— *EXCESS PARKING: DON'T LET IT BE A STUMBLING BLOCK TO GOOD PLANNING* —

Re: Mill Plaza Redevelopment. 7 Mill Road. Continued review of application for site plan and conditional use for mixed-use redevelopment project, drive-through facility for bank, and activity within the wetland and shoreland overlay districts. Colonial Durham Associates, property owner....Central Business District. Map 5, Lot 1-1.

Sheet C-102: Notes

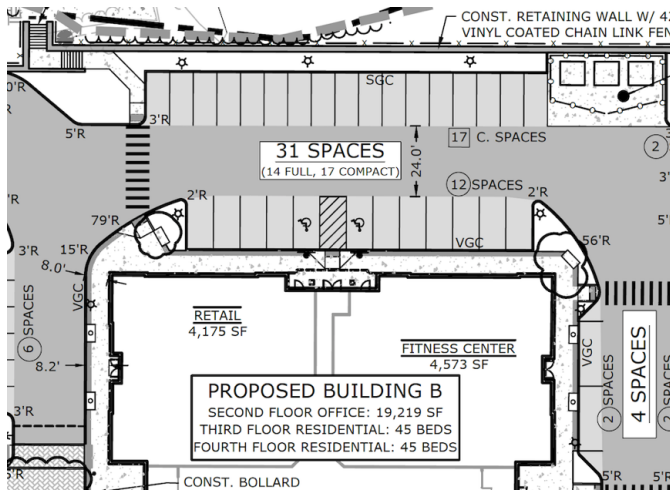
- The Mill Plaza is privately owned. How could an excess of parking here in any way help demand for parking elsewhere?
- If the Board considers a reduction of the 372 proposed parking spaces, how many should be removed, from where, and what would be gained or lost?

18 compact spaces along Mill Road

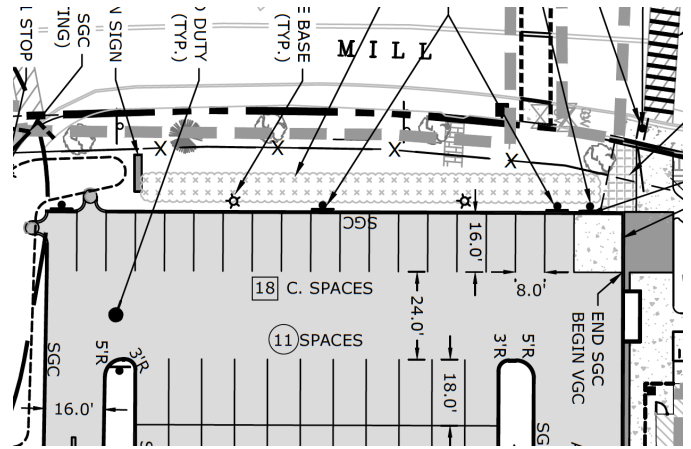
- **Mill Road strip:** 18 compact spaces (of the 179 spaces in front of Building A). These prime spaces have historically been leased: They have not been used by customers of Hannaford or Rite Aid, despite the claims of CDA.

48 spaces south of Building B

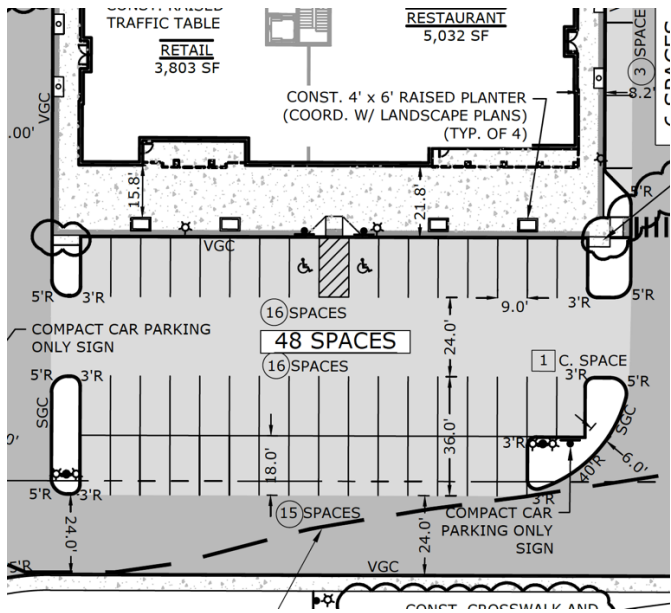
- **South of Building B, toward College Brook:** 48 spaces. This area includes the Jellyfish stormwater management system (perhaps not a concern on the surface?) and would serve a restaurant but is also closest to the residential neighborhood.

Truck Turning Plan

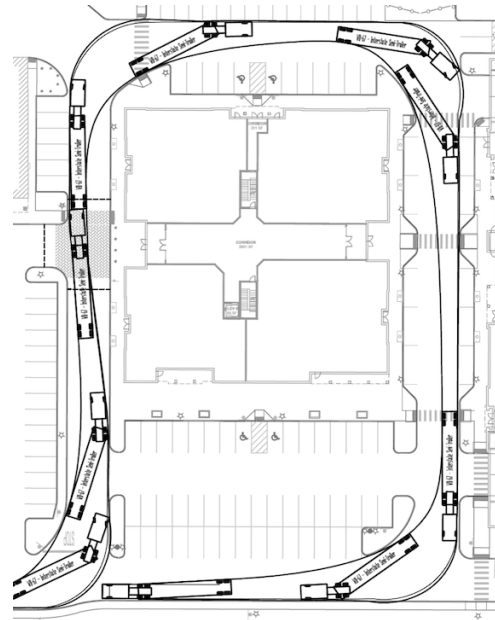
- **North of Building B, below the Grange:** 31 spaces. This area appears to be needed for truck turning (see Sheet C-601), but one row could be removed and still retain that truck access. (If Building B were moved back into that space, could truck access be retained?)

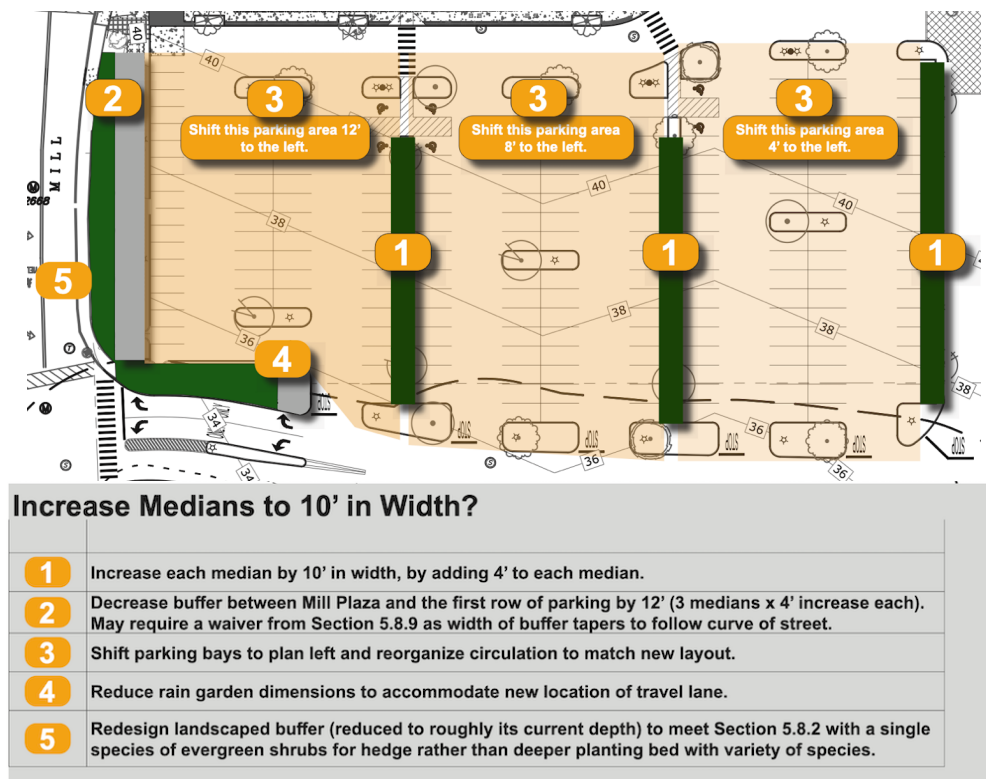
Emily Innes argued for CDA that the change would reduce the buffer. (It was not possible for home viewers to see to what she was referring: buffer to College Brook?) She also argued that the change would have other implications such as on circulation.

I wonder whether CDA seriously brainstormed solutions to the challenges of increasing the width of median strips, particularly since the Planning Board did not ask them to do so. **In other words, no one pointed out that reducing the number of parking spaces might open opportunities both for greater landscaping and solving circulation challenges.**

Recommendation (no surprise): Fewer parking spaces
